ADDENDUM #2: November 8, 2019

FROM: Allied Engineering, Inc.
160 Veranda Street
Portland, Maine 04103
Telephone: (207) 221-2260

RE: Addendum No. **Two (2)** to the Bidding Documents for:
NEW MECHANICS GARAGE LITCHFIELD MAINTENANCE FACILITY MILE
MARKER 92.7

SHEET NUMBER: ES-100

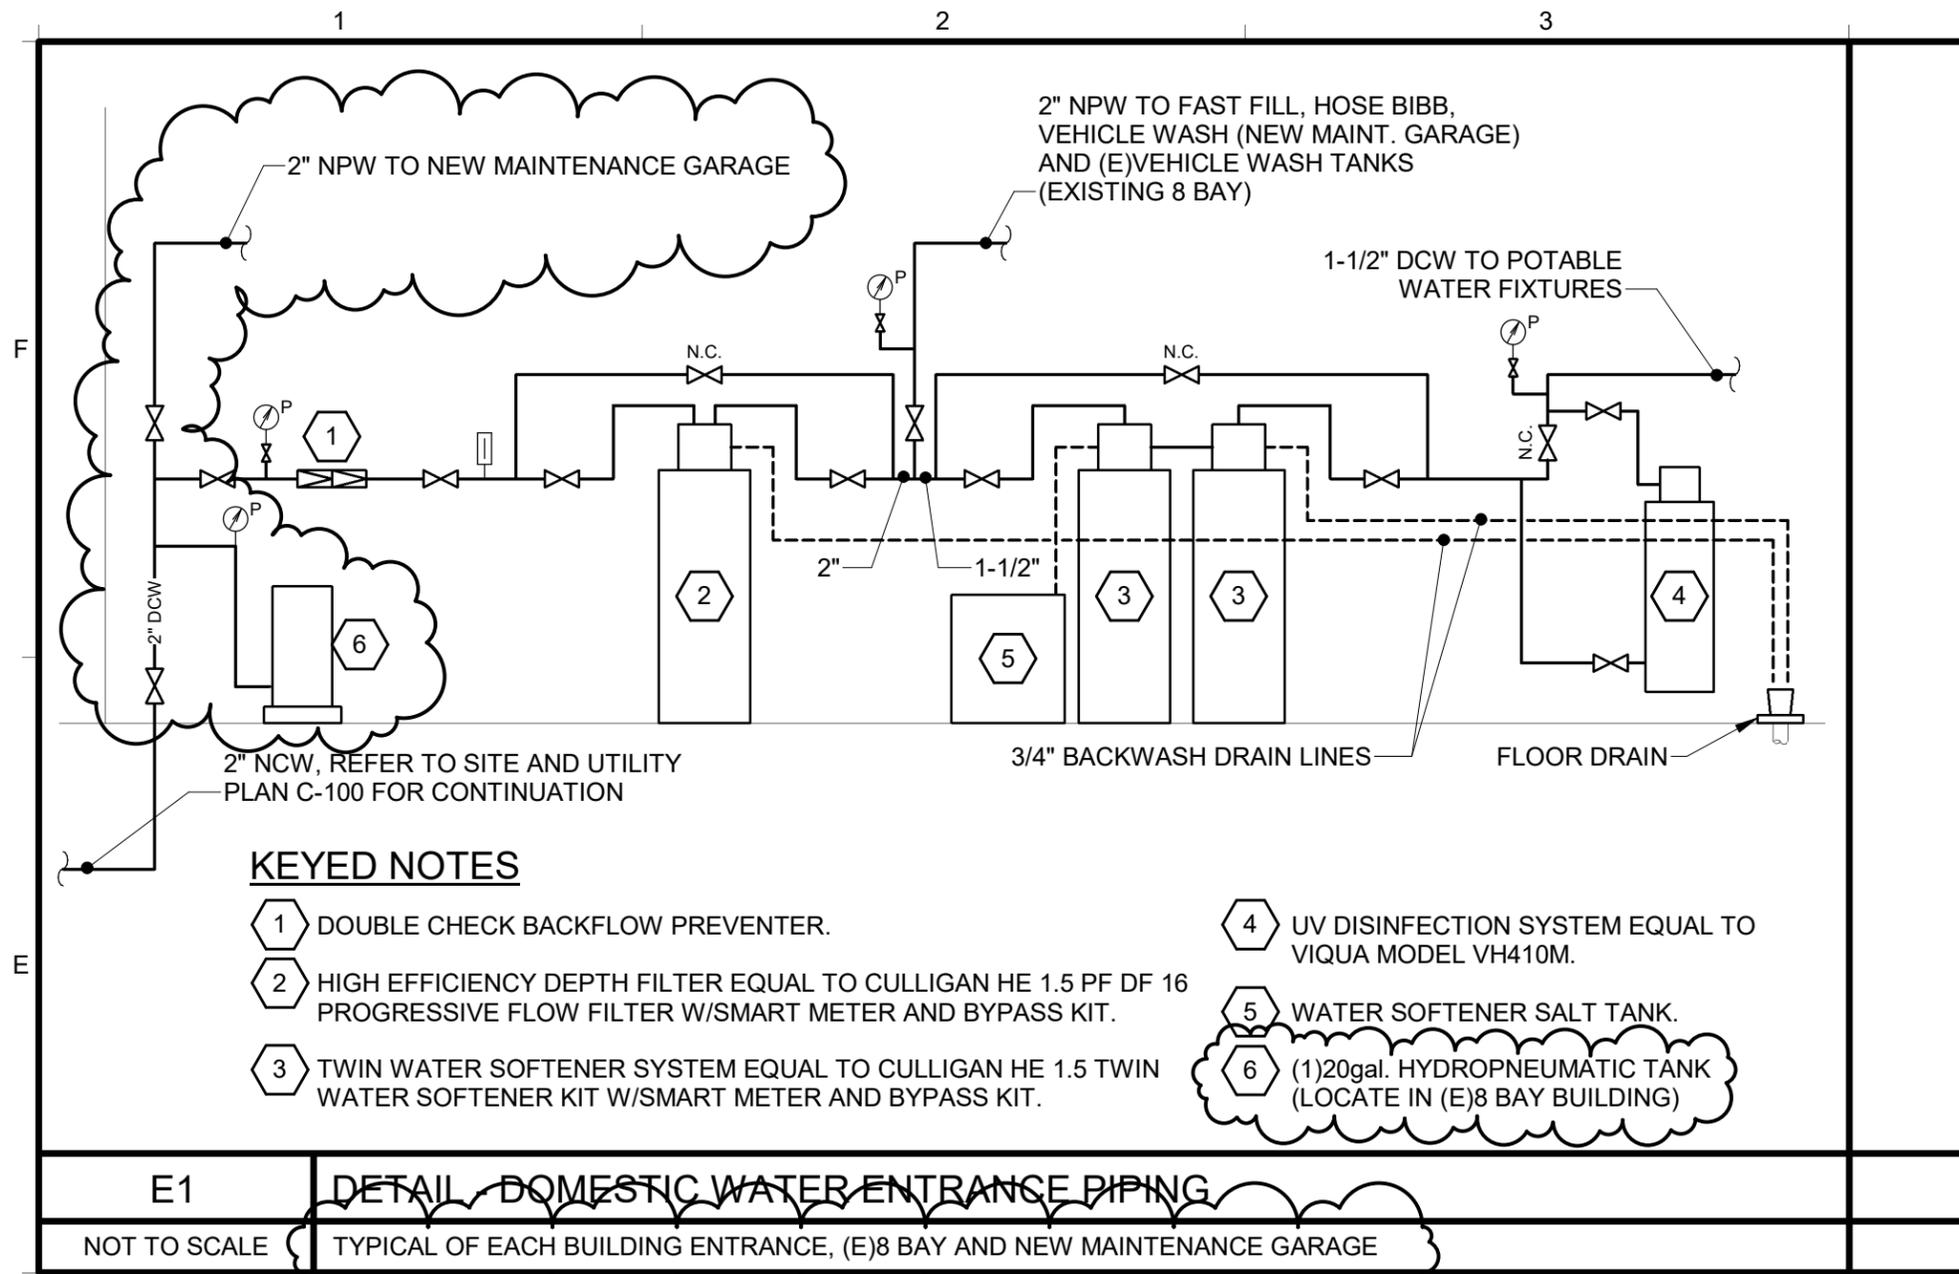
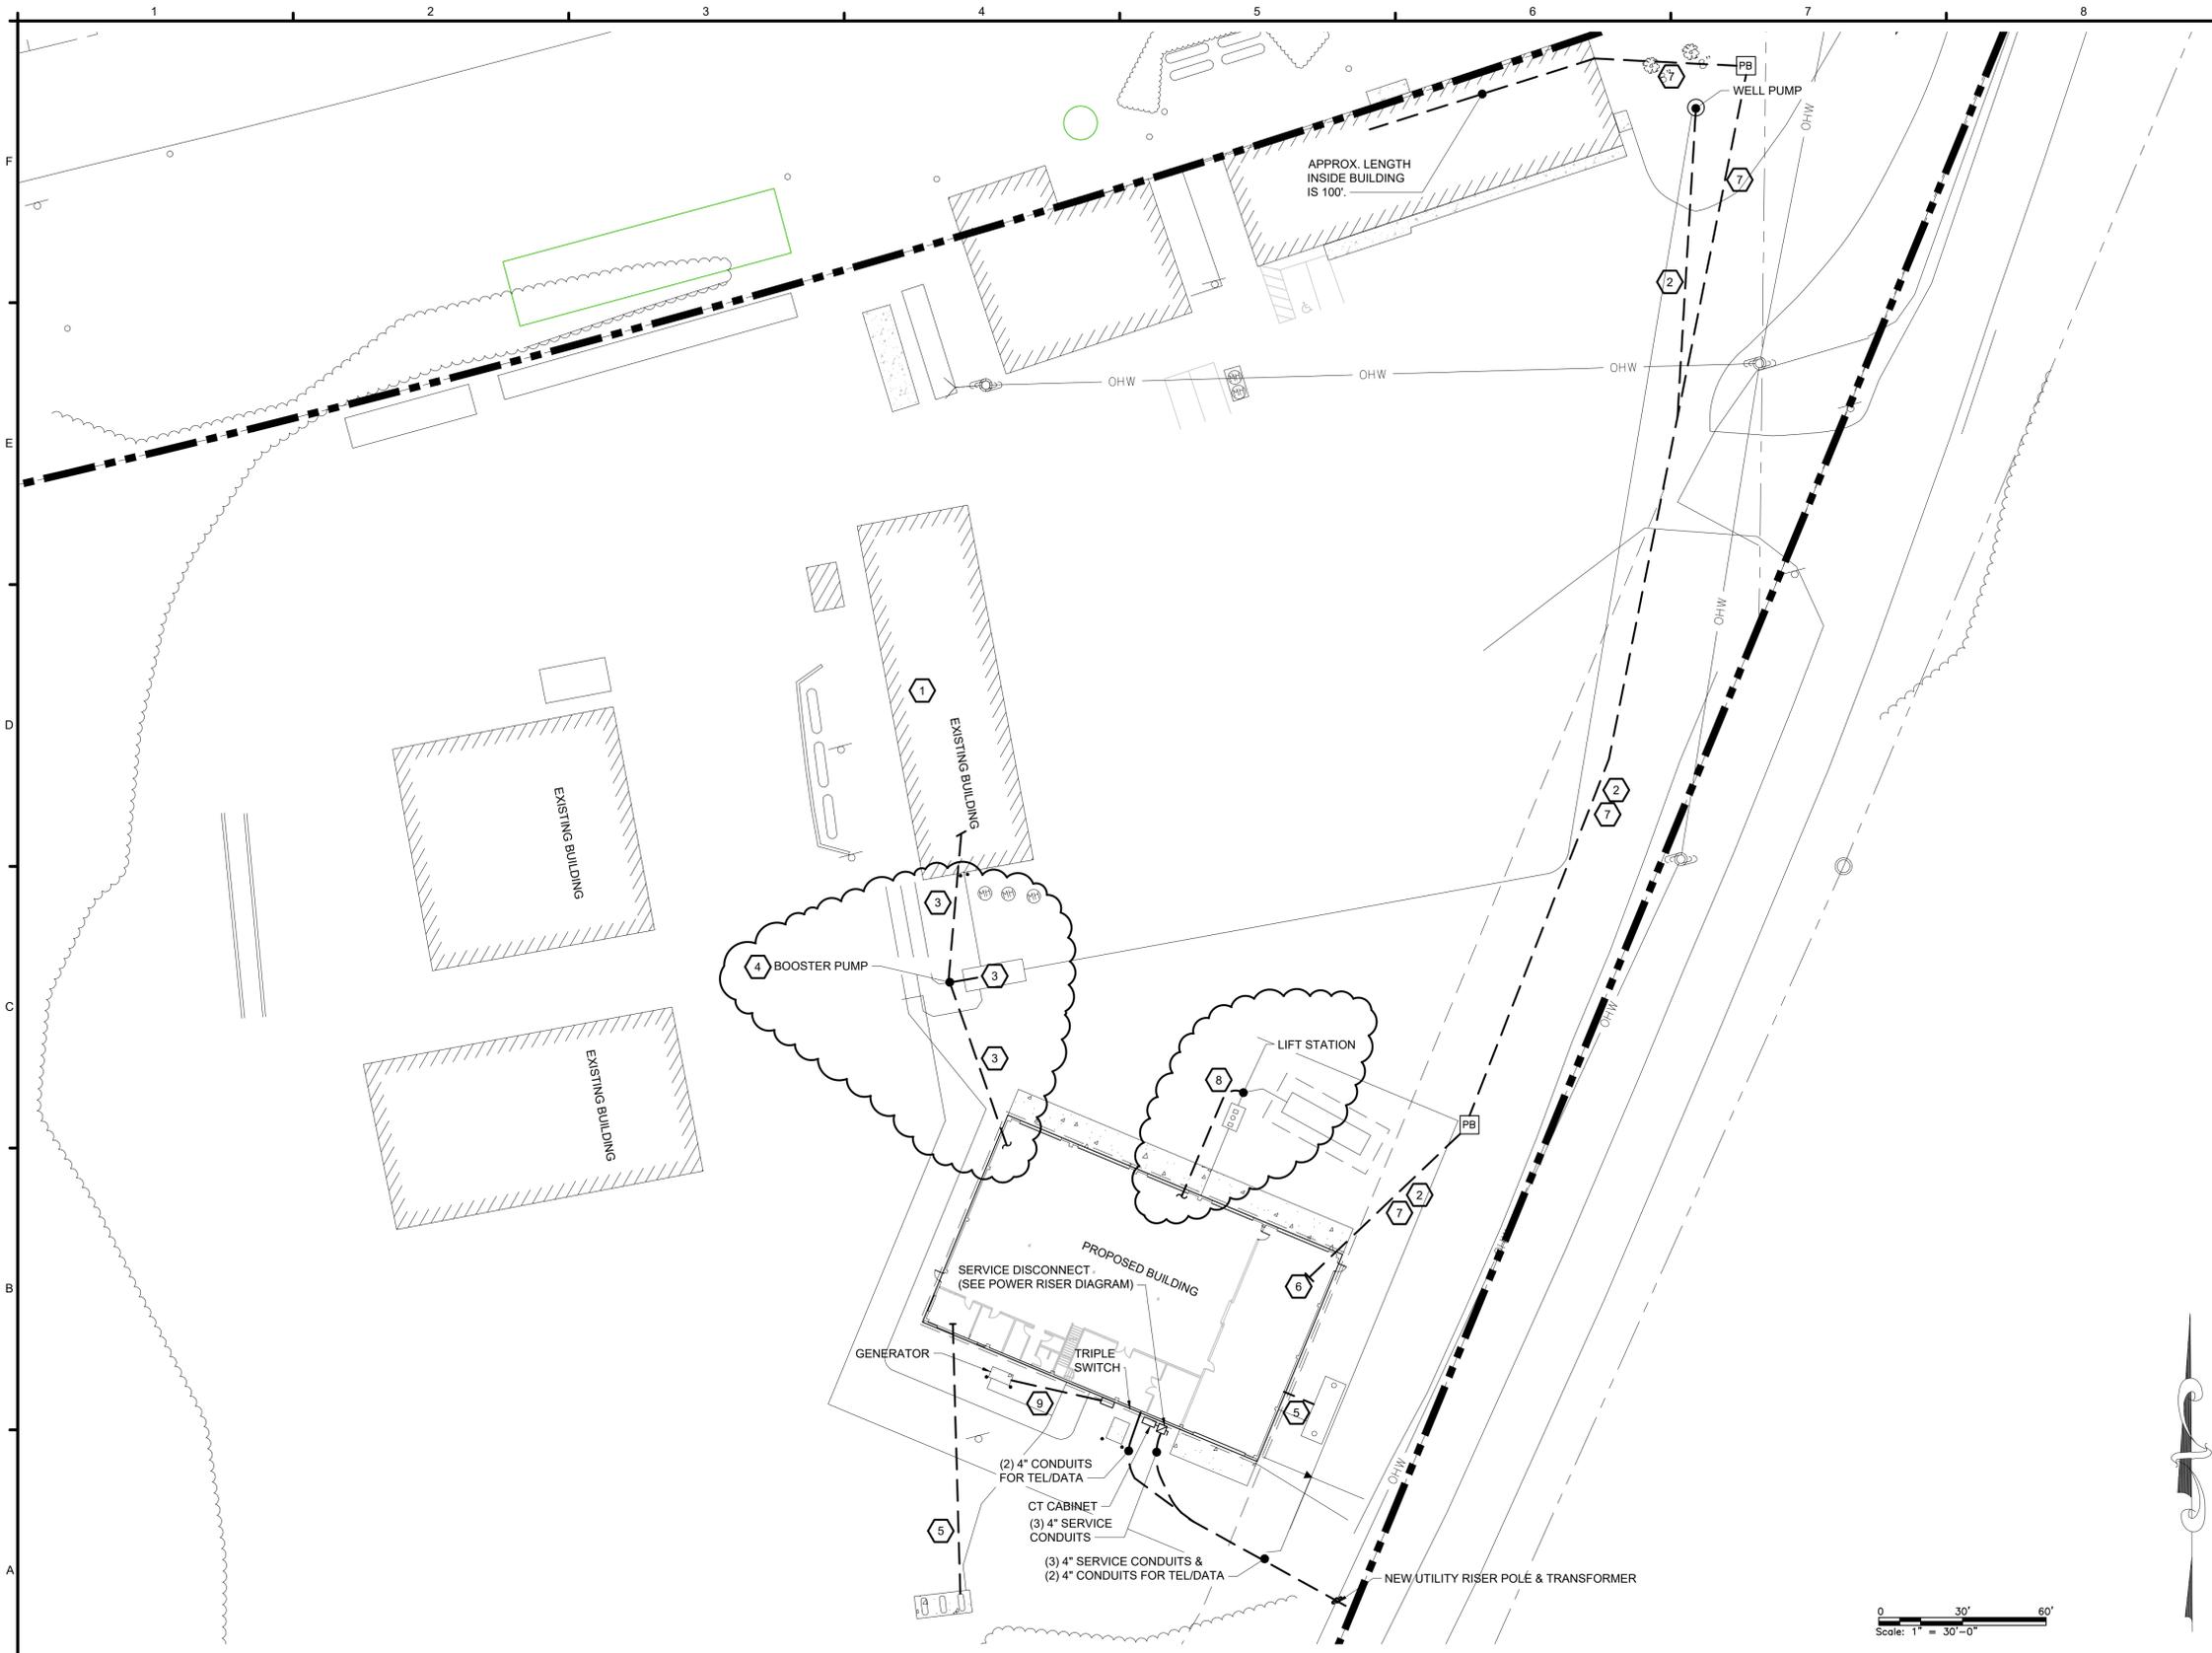
6. DRAWING ES-100 ELECTRICAL SITE PLAN: **DELETE** in its entirety and **ADD** in its place the revised sheets attached to this addendum. Drawing ES-101 has been updated to incorporate changes made to site plan.
